CHAPTER 5

COMMENTS AND COORDINATION

5.1 INTRODUCTION

Figure 2-2
10-Southbound Lanes Site Plan
 VIRGINIA AVENUE PEDESTRIAN FACILITY & I-5 SOUTHBOUND REALIGNMENT

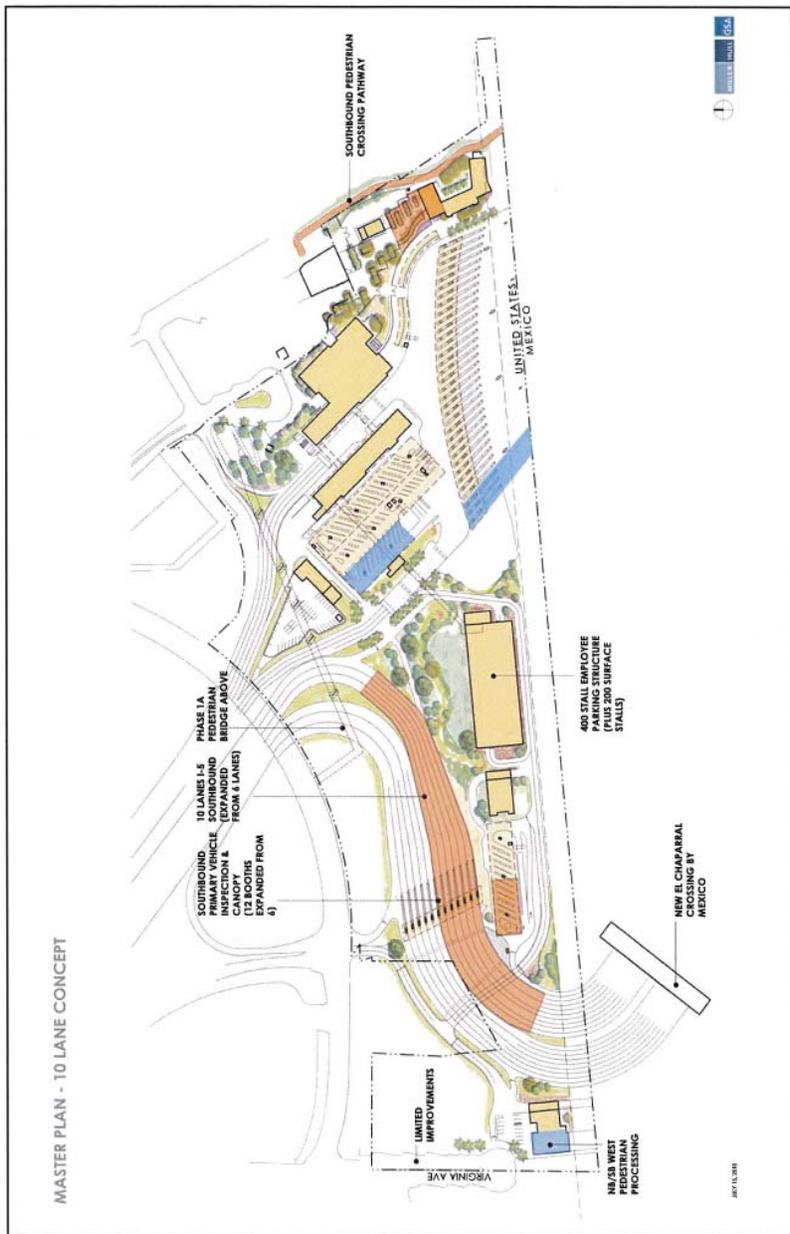
D10 3) Figure 2-2: 10-Lane Alternative comments:
• Do not show the lanes being split immediately in half by delineation just to show the 6 lanes on the south side segment (shaded in orange). See Attached.

D11 • Figure 2-2 is a 12-lane configuration.

D47 34) Figure 2-2 shows the 10 lane configuration alternative. In this drawing, the 10 lanes do not reach even half way to CDLP Bridge. The queue calculations assume 10 lanes to the bridge (0.2 miles).

- D9 See response to comment D8.
- D10 See response to comment D5.
- D11 Figure 2-2 in the traffic report has been updated to reflect 10 lanes in the southbound roadway.
